ADDENDUM NO. 2
TO THE CONTRACT DOCUMENTS
for the construction of

Date: April 9, 2021
Project No.: D3226100

C.C. WILLIAMS WASTEWATER TREATMENT PLANT
DEWATERING AND OTHER IMPROVEMENTS PROJECT

MOBILE AREA WATER AND SEWER SYSTEM
MOBILE, ALABAMA

2605-420

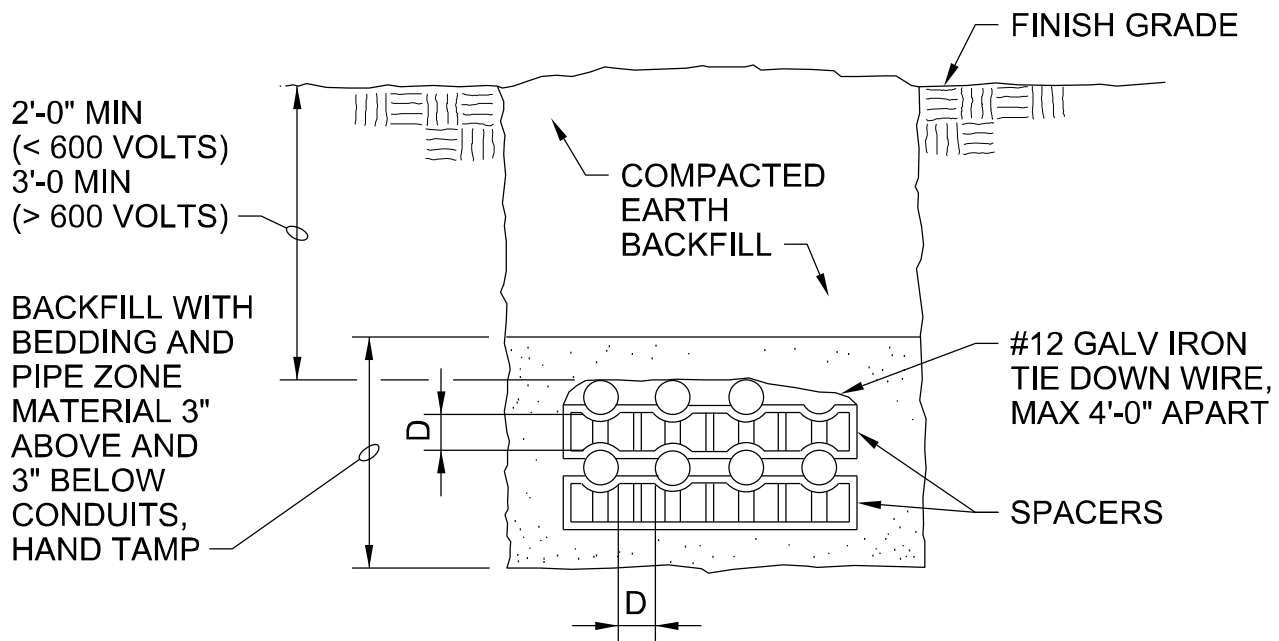
4. Drawings 20-E-2001, 20-E-4001 and 20-S-2002 (and others) - A minimum distance of 4 feet shall be maintained between 20MCC-1 and 20LVSG-1 after accommodation of the length as revised above.
5. Drawing 95-E-5003 - Add detail 2605-420 as indicated in Addendum 1 but omitted from the distribution. See attachment for this detail.
